## New ventilation system of the brake disc for 22.5" tyres

In June 2016 BPW will introduce an optimized design of the brake disc for 22.5" tyres (for the brakes TSB 4309 und TSB 4312).

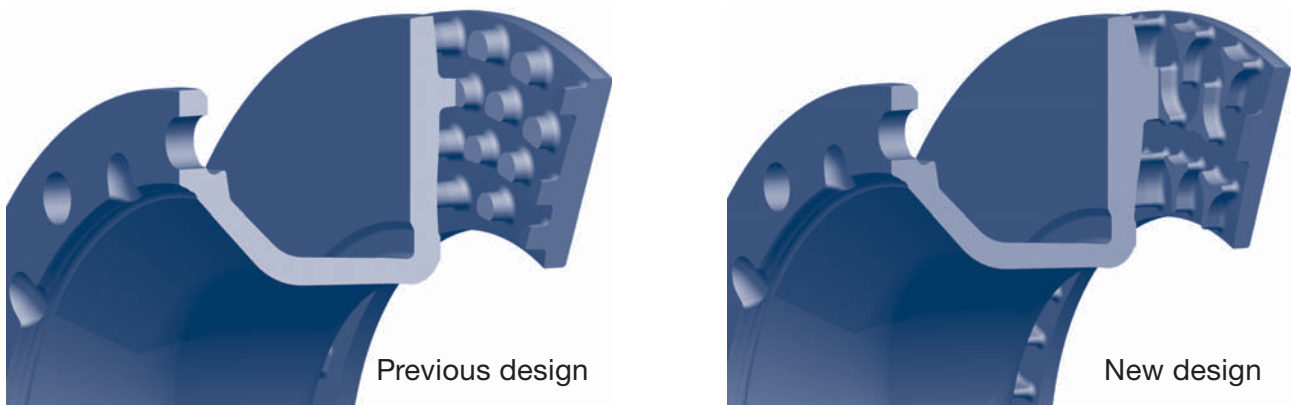
- › The special "Y-shape" and arrangement of the pillars improves the heat crack resistance.
- › The offset venting channel provides a better ventilation of the disc and therefore low operating temperatures and a reduced wear.
- › The friction rings of the brake disc have a different thickness while maintaining the same wear volume. The increased mass on the flange side increases the heat absorption capacity and the resistance against heat cracks is improved.

The change of the brake disc takes place within the existing part number and has no influence on existing approvals.

The discs are interchangeable and a mixed fitting of an old and new brake disc on one axle is possible.
